City of Richmond

Report to Committee Planning and Development Department

File: RZ 13-649998

Re: Application by Yamamoto Architecture Inc. for Rezoning at 10591, 10611 and 10631 Gilbert Road from Single Detached (RS1/E) to Low Density Townhouses (RTL4)

WITH
TAMMACHO ARCHITECTURE INC.
DRAWING TITLE
TREE MANAGEMENT
PLAN

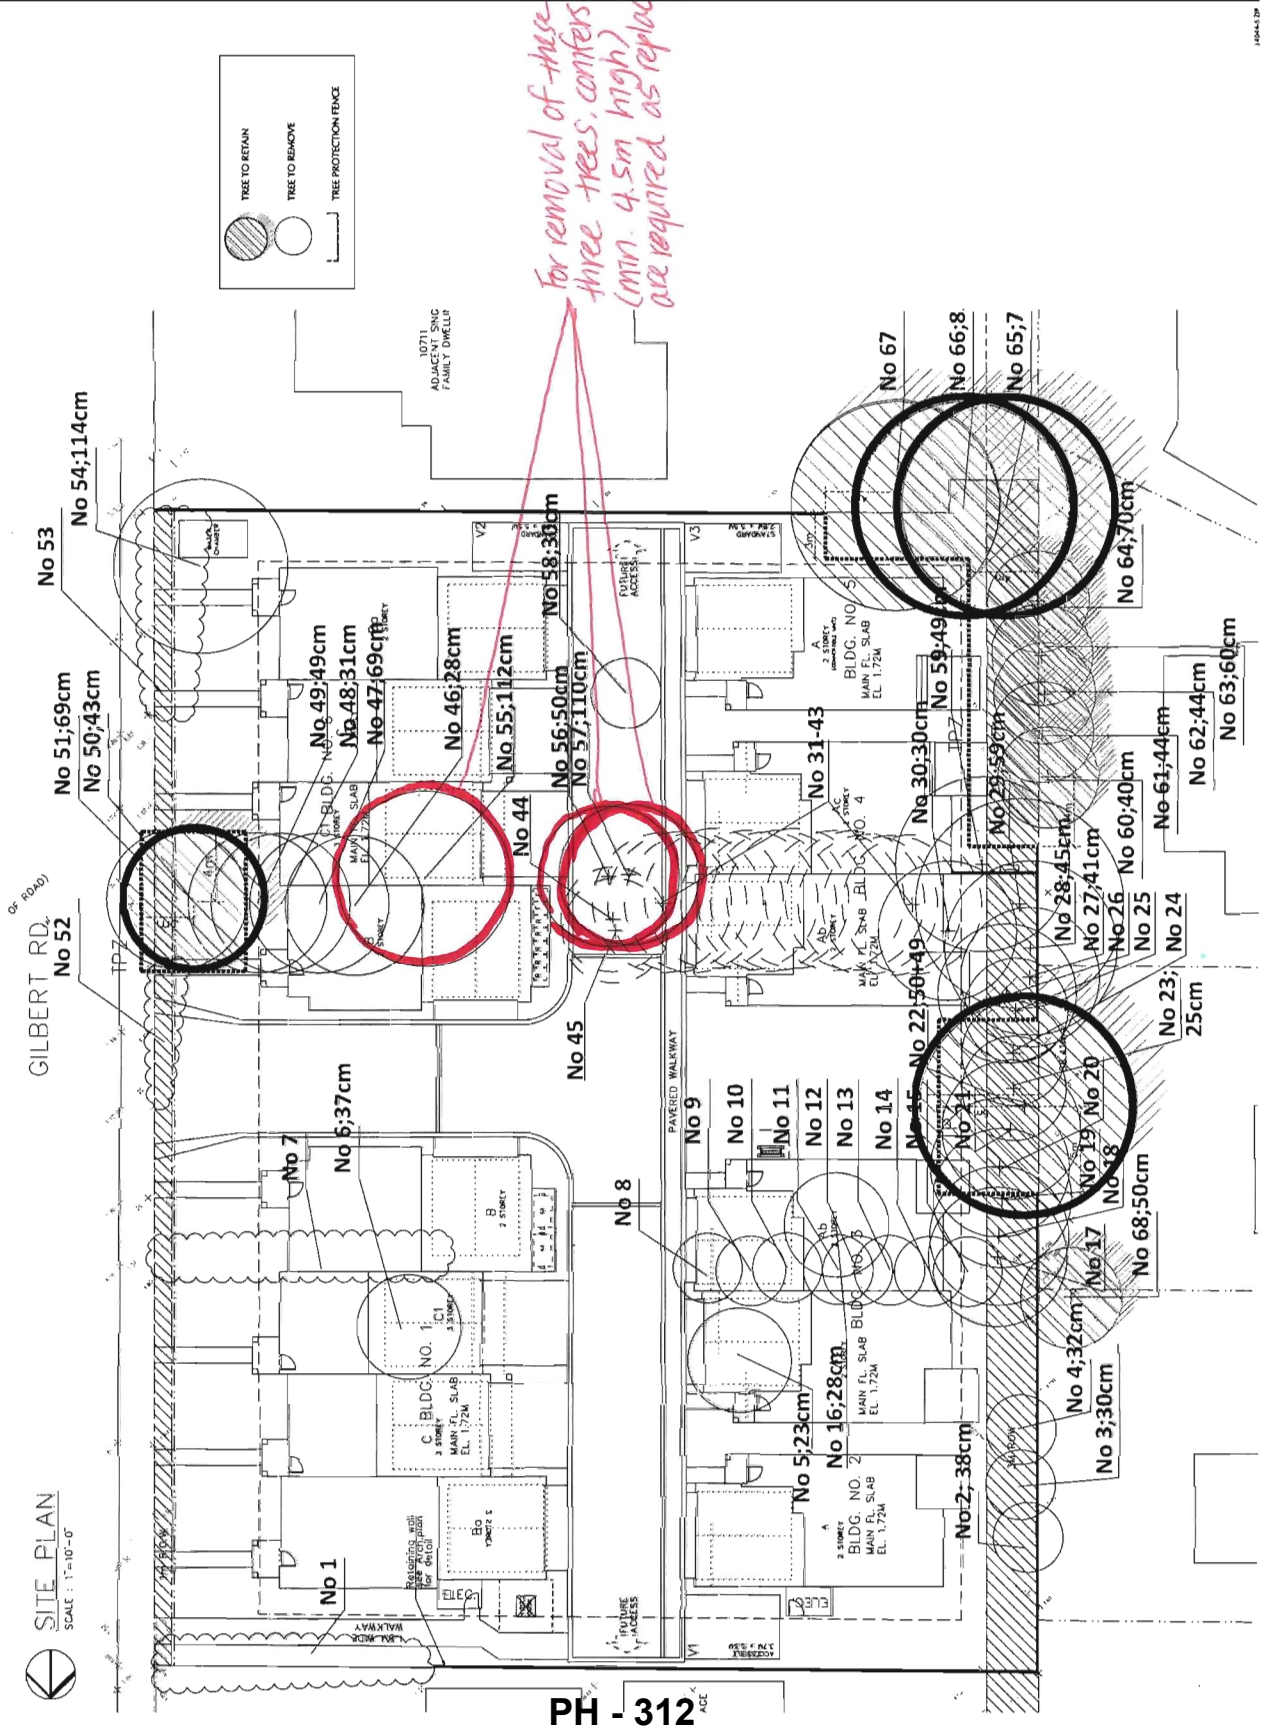
- Four (4) trees, Sycamore Maple (tag# 22), Hemlock (tag# 50), two Douglas Fir trees (tag# 65 and 66), are in good condition and are to be retained and protected (Attachment 4).

- Seven (7) neighbouring trees, specifically tag# 60, 61, 62, 63, 64, 67 and 68, are to be retained and protected.
- Four (4) remnant Cedar hedges, identified as tag# 1, 7, 52 and 53, have marginal landscape value and should be removed.

- Three (3) trees, a Pine (tag# 55) and two Cedar trees (tag# 56 and 57), are in fair condition but located in the middle of the site (i.e. on the proposed drive aisle or within the building envelope). In order to successfully retain these trees, four (4) units would need to be eliminated from the proposal. Removal and replacement with conifer (minimum 4.5 m high) is recommended. The applicant has agreed to provide conifers (minimum 4.5 m high) as replacement trees and is required to show them on the Development Permit drawings.

- 32 trees located on site have been previously topped or have significant dieback and/or sparse canopies. As a result, these trees are not good candidates for retention and should be replaced.
